Certified Action of the City of Raleigh Planning Commission

Case File / Name: SP-38-12 / Hayes Barton Family Life Center Addition

Nature of Case: This request is to approve a 3-story 59,536 square foot addition to an existing 56,600 square foot church facility on 2.64 acres, zoned Residential-4.

SP-38-12 / Hayes Barton Family Life Center – Site Plan

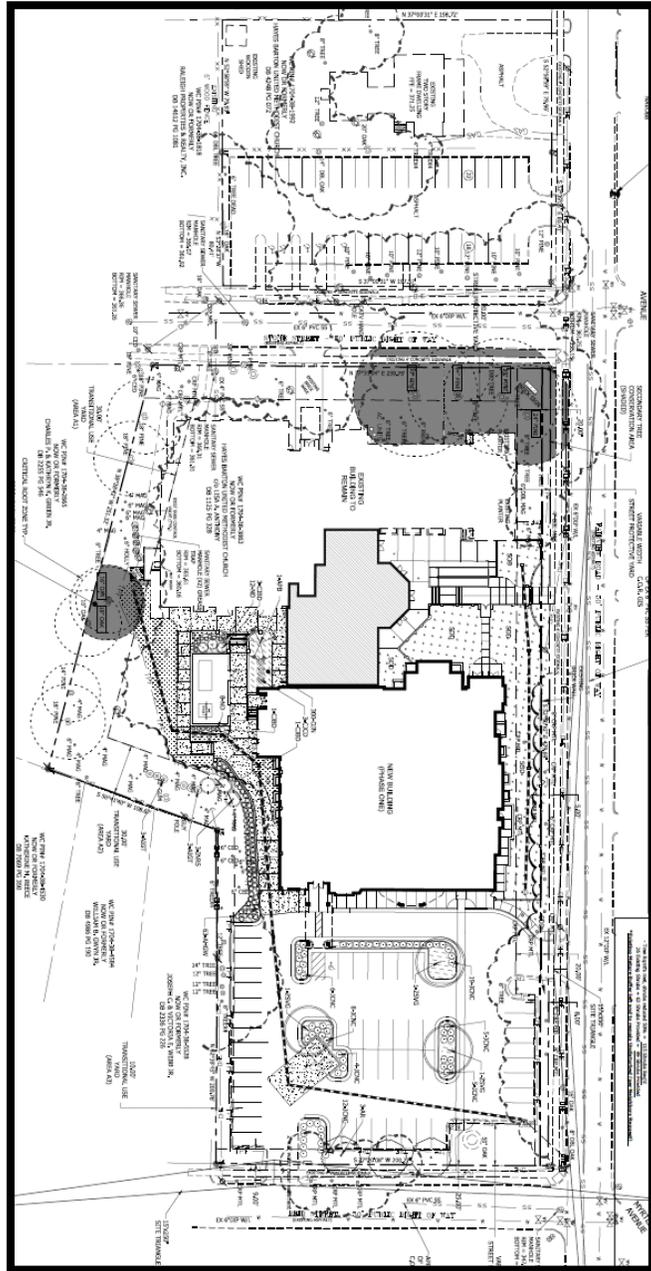
An alternate means of compliance is being requested along the southwestern property line where the existing parking lot is 8' from a single-family residence. 32 existing evergreen holly trees separate the parking from the single-family residences.

On other portions of the southwestern property line, a 20' in width area, 52' in length and 10' in width 140' in length has existing vegetation and will be left undisturbed. 94 shrubs are being planted in the buffer, 26 short of the required 120.

- (1) That the Planning Commission approve an alternate means of compliance from providing a 30' Type B Transitional Protective Yard along the southwestern property line in accordance with Code Section 10-2082.4;
- (2) That the Planning Commission finds that this site plan meets the standards for approval of Code Section 10-2132.2(d);

- (7) That the developer shall pay to the City a stormwater facility replacement fund payment equal to twenty-four percent (24%) of the estimated cost of constructing all stormwater control facilities shown on the development plans;
- (8) That a bicycle rack is added to the plans prior to permit issuance;
- (9) That a tree conservation map be recorded with metes and bound showing the designated Tree Conservation Areas and shall be in compliance with Code Section 10-2082.14;

- (10) That ½-60' right-of-way along Fairview Road is dedicated to the City of Raleigh and a copy of the recorded plat be provided to the City prior to building permit issuance;
- (11) That in accordance with Code Section 10-2081(c)(3)(a) written verification is provided to City Staff that the off-site parking lot (DB04248 PG0072; Pin # 1704381992) is owned by the church and will provide parking for the church and the church agrees in writing that if the off-site parking is no longer provided and no equivalent parking is provided, the church and its successors will discontinue the principle use or provide required off-street parking;
